# Hui Zhou Gaoshengda Technology Co., LTD

## Declaration of Differences in Tested Devices

We, Hui Zhou Gaoshengda Technology Co., LTD, declare on our sole responsibility for the product change of W7LM1110, W7LM1110A, for more details of change please refer to as below.

### 1. For W7LM1110

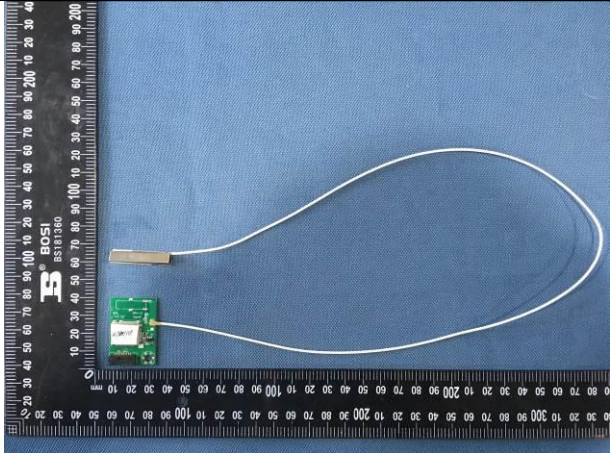
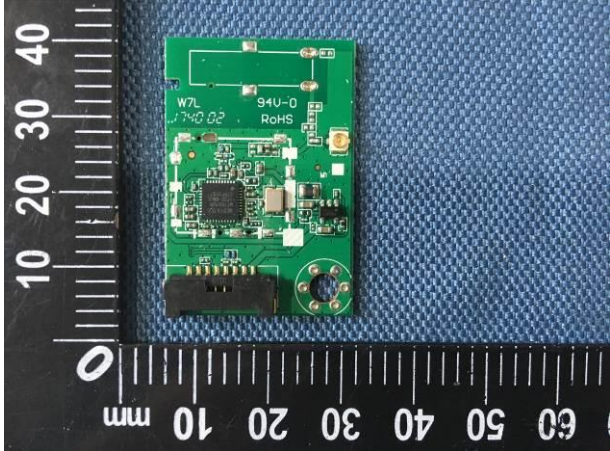
Old	New
N/A	<ol style="list-style-type: none"><li>1. Replace the new antenna (The antenna gain is changed from maximum 3dBi to maximum 1.88dBi).</li><li>2. Adding two 0 <math>\Omega</math> resistance</li><li>3. Add a RF test point.</li><li>4. Remove the white IPex</li></ol>

## 2. For W7LM1110A

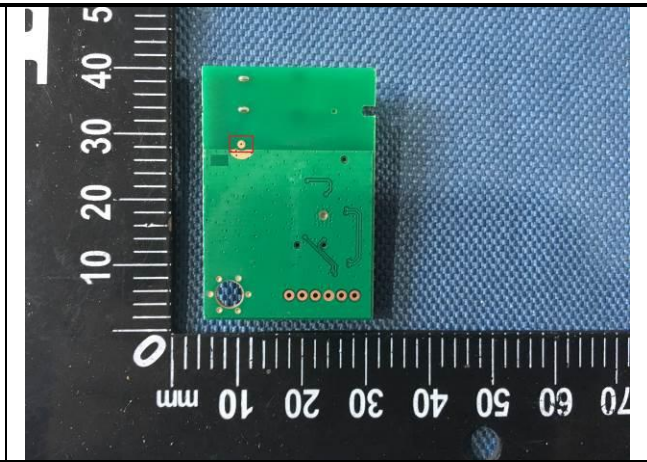
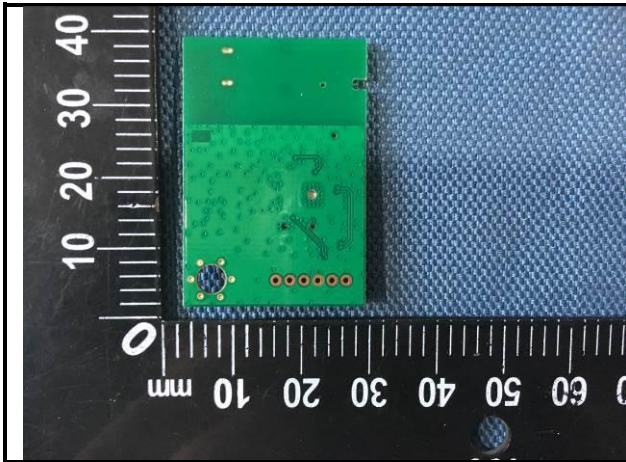
Old	New
N/A	<ol style="list-style-type: none"> <li>1. The antenna has not changed and the rf characteristics have not changed.</li> <li>2. The new Layout, IC and RF part has not changed</li> <li>3. Add two solder joints to the top.</li> <li>4. RF changes ground capacitance encapsulation.</li> <li>5. Power supply circuit modified 3.3V power supply, reserved 5V power supply.</li> <li>6. Power supply &amp;IO interface change.</li> </ol>
